Stage Inspection Report - Pre Slab Steel

Lot Sample, Sample, VICTORIA, 3030

Report/Agreement # 2103221650989

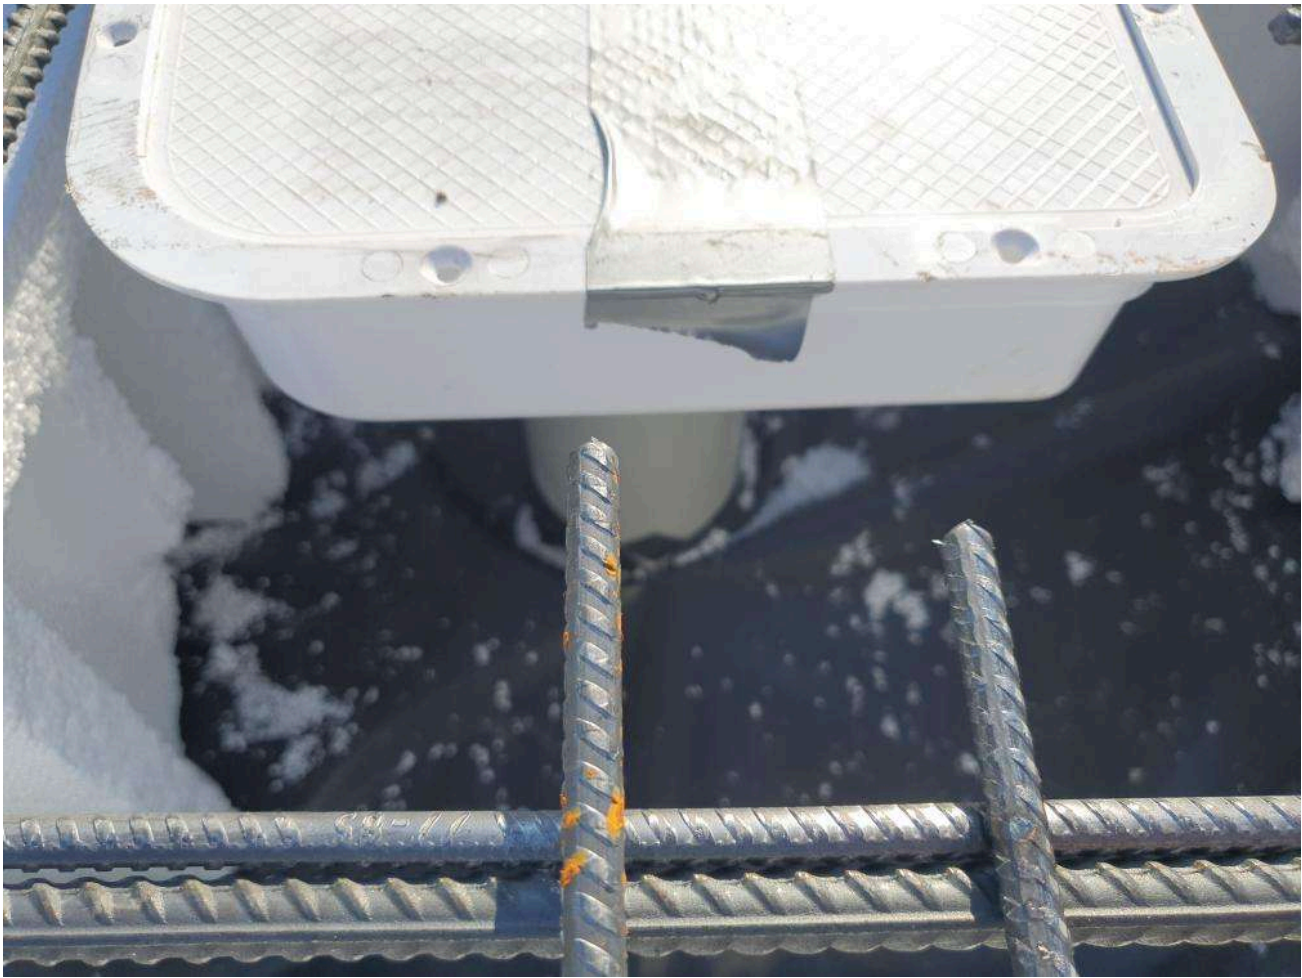
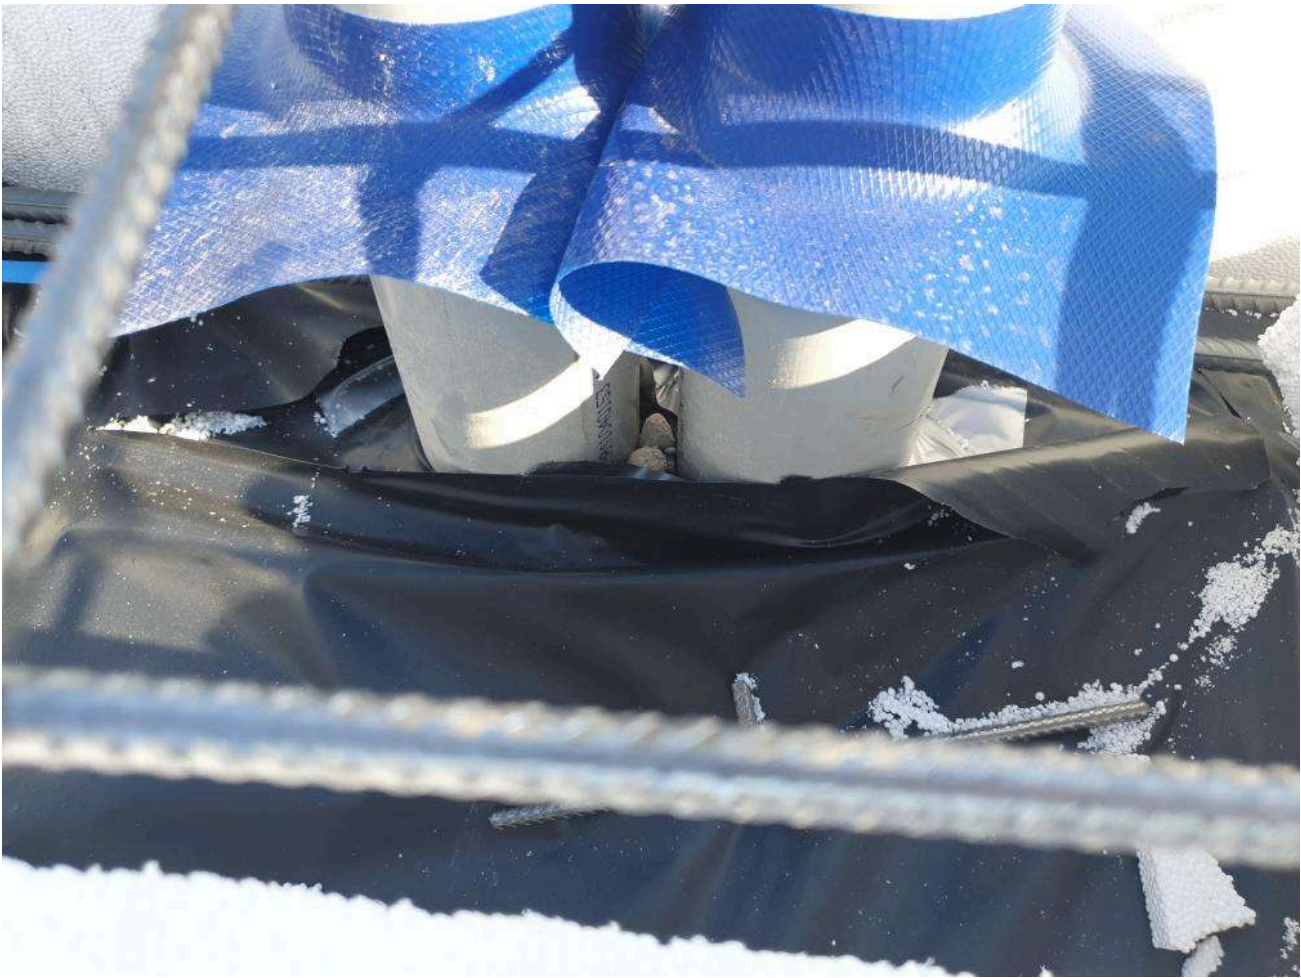
Section(s) of form work timber is missing

Some areas of boxing still need to be

completed, prior to any concrete pour, to avoid any blow-out and widening.

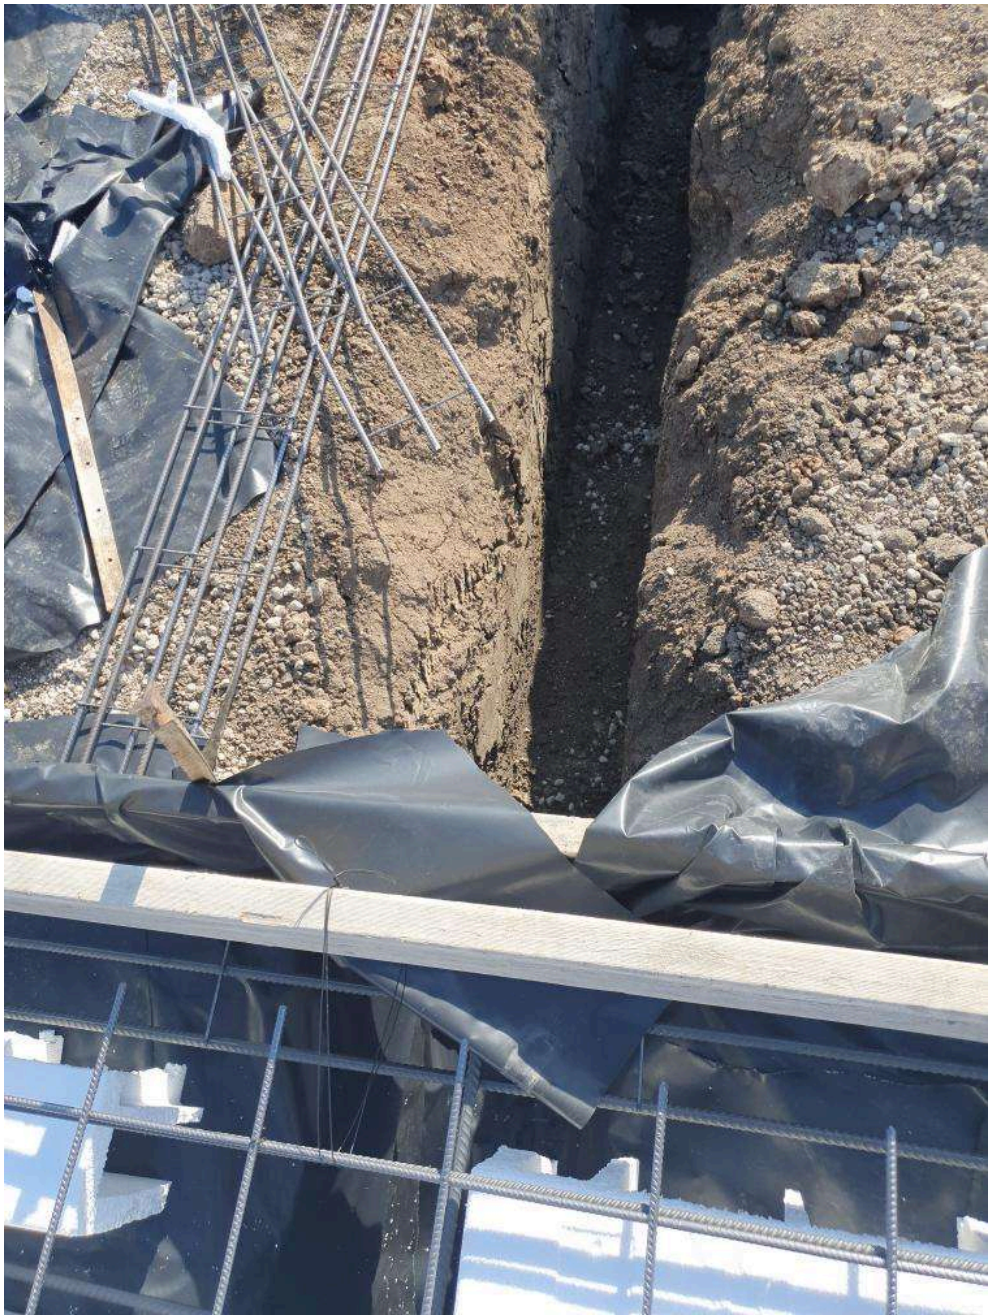
Sections of the trenches have rubble and spoil. Clean out prior to pour.

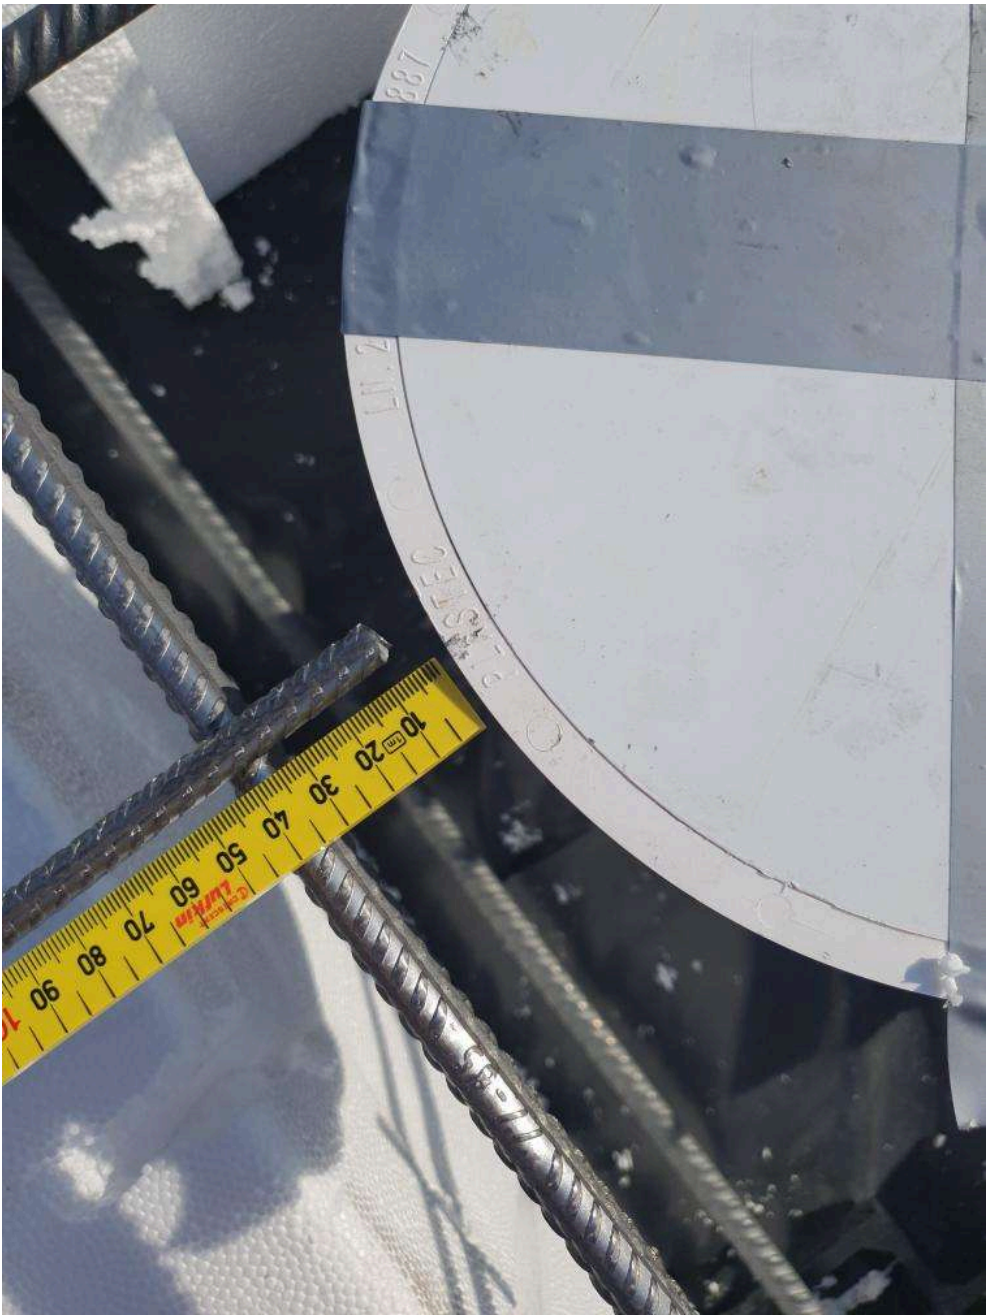
The steel reinforcement does not conform in that sections of the Steel mesh do not overlap in accordance with the Australian Standards in areas

We recommend that the mesh be installed correctly prior to concrete pour or an engineers justification provided by the builders engineer.

AS 2870, Section 3.2.3.2 (c) Steel Reinforcement require that the 2 outermost wires overlap in accordance with Figure 3.2.3.1 as below.

The steel mesh installation does not conform in that.....

AS2870 3.2.3.2 (d) Steel reinforcement states that *Footings and slabs-on-ground must have concrete cover between the outermost edge of the reinforcement (including ligatures, tie wire etc.) and the surface of the concrete of not less than the following:*

- (i) 40 mm to unprotected ground.
- (ii) 30 mm to a membrane in contact with the ground.
- (iii) 20 mm to an internal surface.
- (iv) 40 mm to external exposure.

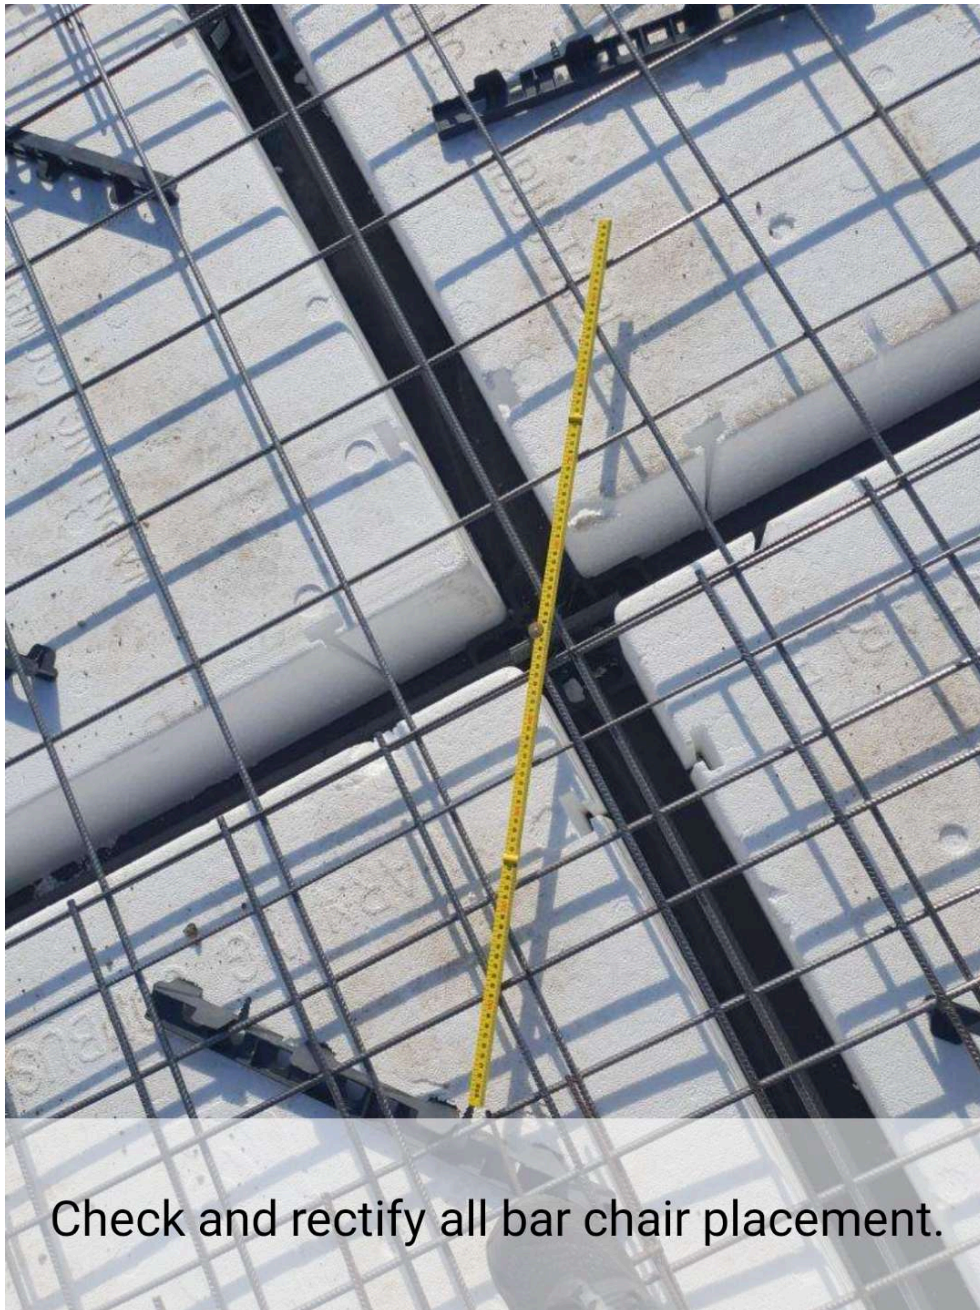
Support of the steel mesh does not conform in that sections of the bar chair spacing exceed the maximum spacing required.

AS2870 3.2.3.2 (v) Steel Reinforcement states that bar chairs must be spaced at not more than 800 mm centres for steel fabric.

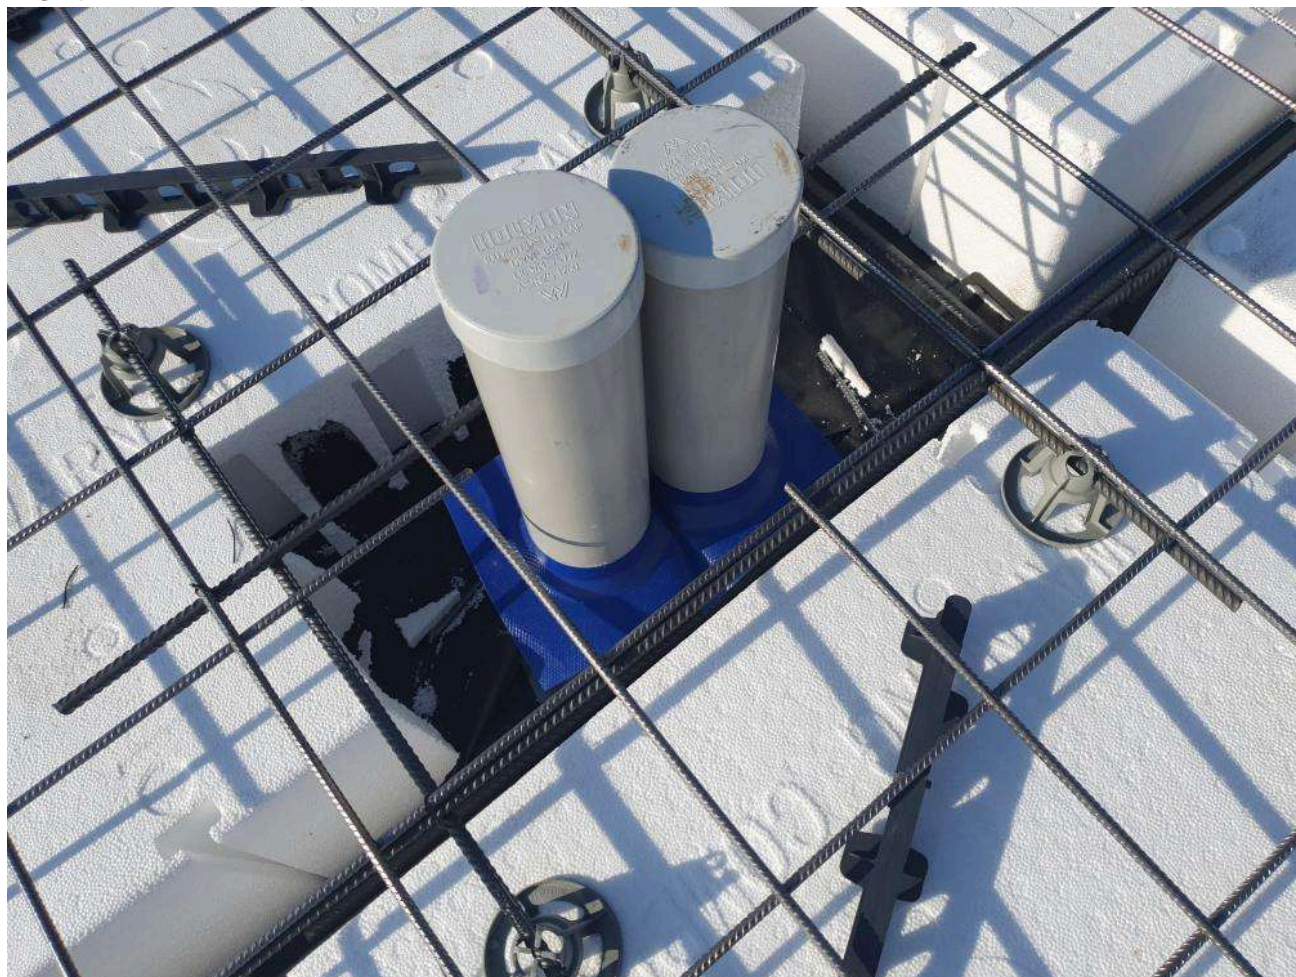
The mesh to the garage/porch area has been installed too low and requires securing in position prior to pour.

Check and rectify all bar chair placement.

Secure Mesh prior to pour

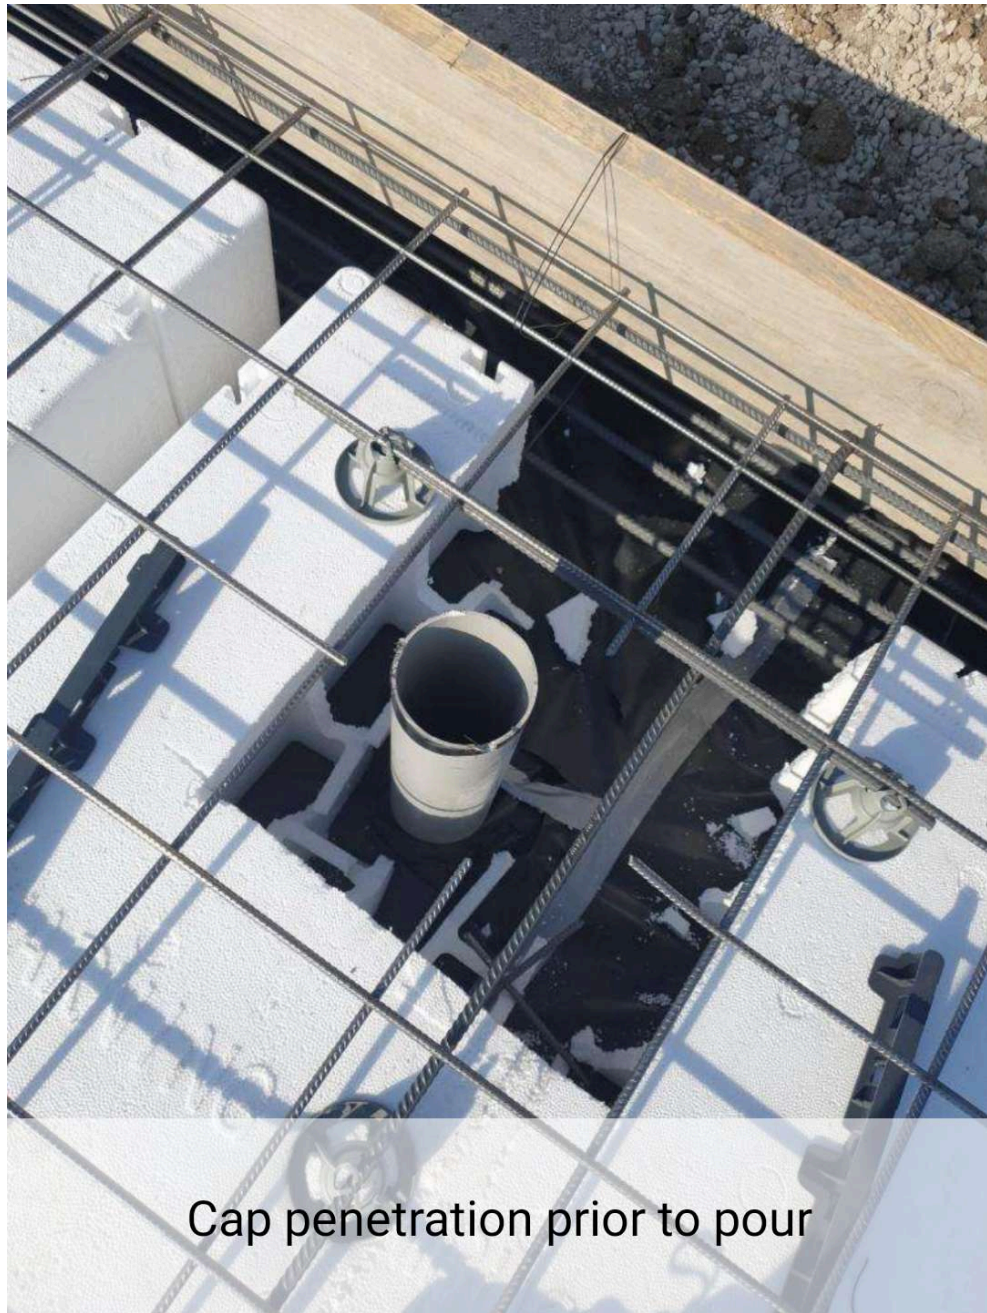
Lagging to the pipes penetrations has not been installed.

We recommend that the builder ensures that all lagging is installed as per **AS2970-2011 Residential Slab and Footings** prior to concrete pour.
